címa **CAPITAN** incorporated

Pursuant to Rule 701-E-5, please consider this letter as our application for one additional water injection well, and for administrative approval of said well, in our Red Lake waterflood project. The original flood was authorized under Order No. R-2461, Case No. 2775 on March 20, 1963. We respectfully hereby apply for administrative approval for the conversion of our Well No. 8, SE/4 NW/4 SW/4 Section 22, T 17S, R 28E, Eddy County, from a producing oil well to a water injection well. The well is shown on the attached plat.

CIMA CAPITAL, INC. RED LAKE WELL No. 8

INJECTION WELL COMPLETION

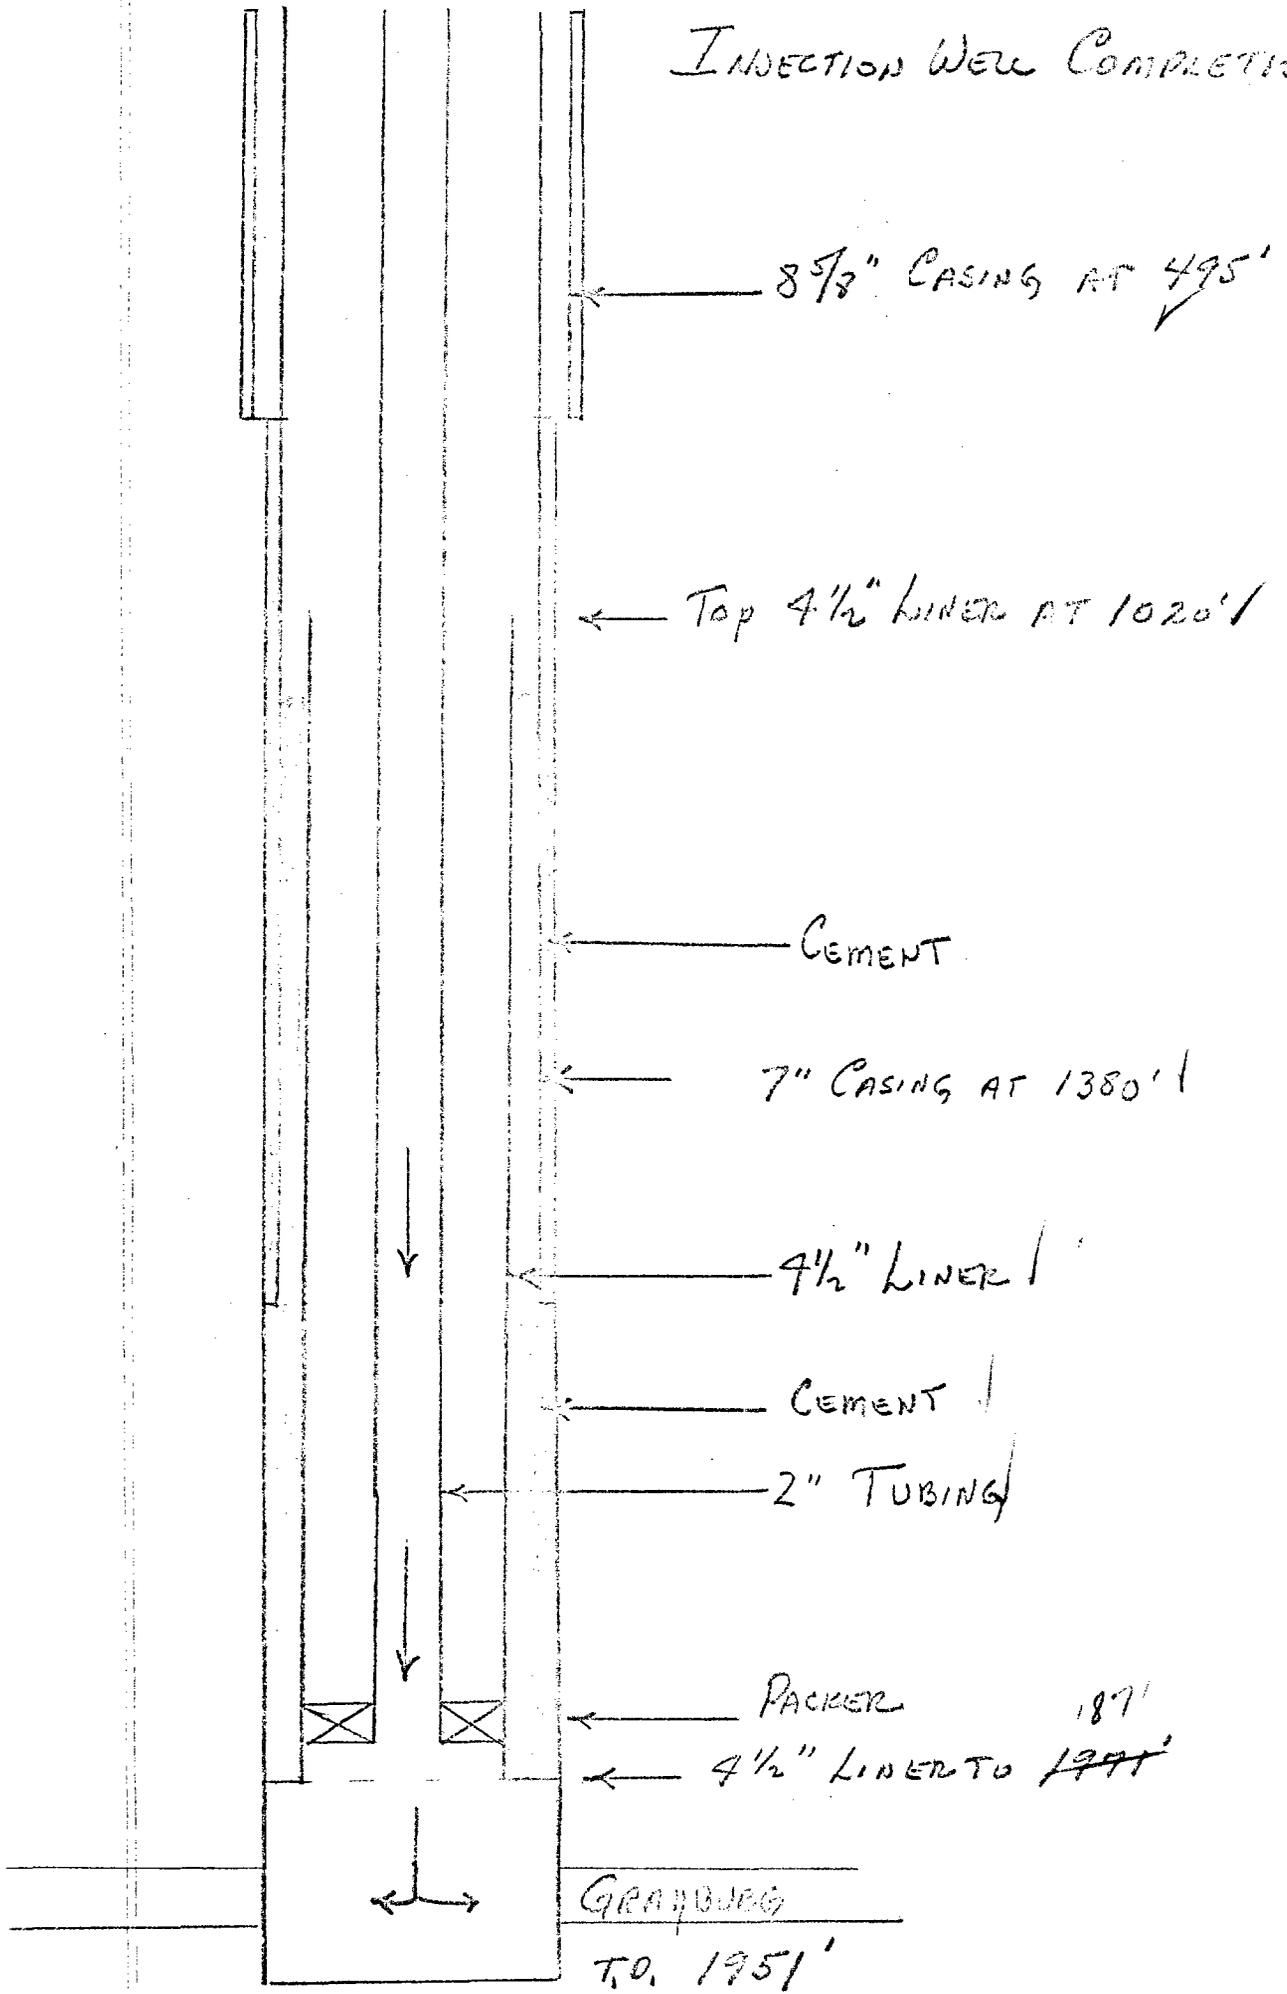
Thank you for your telephone call today. I would like to correct the schematic drawing of the proposed injection well completion on our Red Lake Well No. 8 which I sent to you and to Mr. Nutter on August 8, 1966, along with a request for administrative approval for conversion of this well to injection.

The 4½" liner is set at 1871 feet rather than 1971 feet as shown on the drawing. Would you please correct this on your copy?

The 8 5/8" surface casing is set at 495 feet and is not cemented, but was mudded. The 7" casing is cemented with 50 sacks in 8" hole. Top of the cement is calculated to be at 705 feet. The 4½" liner was cemented with 75 sacks Incor Class C cement. Top of the cement is calculated to be at 1071 feet outside the 4½" liner.
